To: Script Ad Hoc
 From: Debbie Anderson, SEI, UC Berkeley
 Date: 16 May 2022
 Subject: Responses from experts on Palaeohispanic

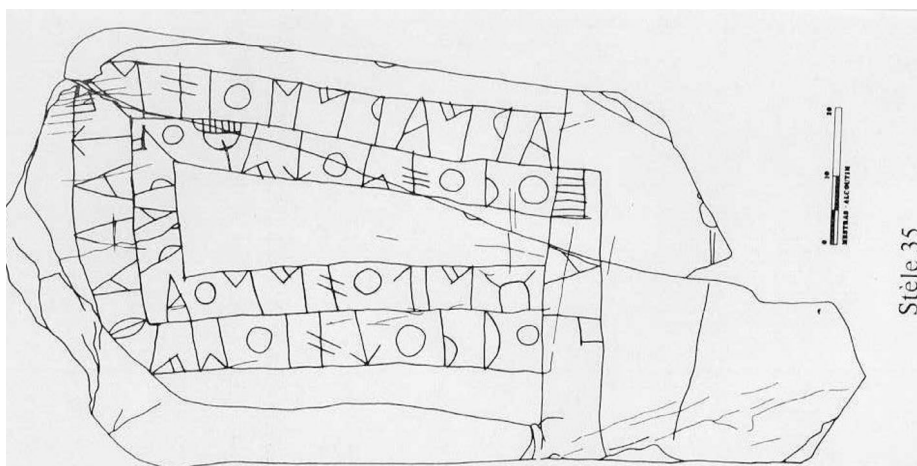
Question from Debbie Anderson: For the 4-, 5-, and 7-bar signs, which are identified as variants of 1024D, the three-bar SOUTHERN PALAEOHISPANIC LETTER PU-BU, do you have figures on their usage (which could help answer the questions whether some contrast with others or if any of these are hapaxes)? The Script Ad Hoc requested this information in order to understand them better.

On the subject of examples of scaliforms with 4, 5 and 7 bars, we attach J.4.1 with a case of a 4-bar scaliform in front of u, i.e. pu-bu, and one of 5 bars in front of o, i.e. po-bo. We also attach an image of J.10.1 with a 7-bar scaliform in front of a, probably one of the cases of te-de in front of a.
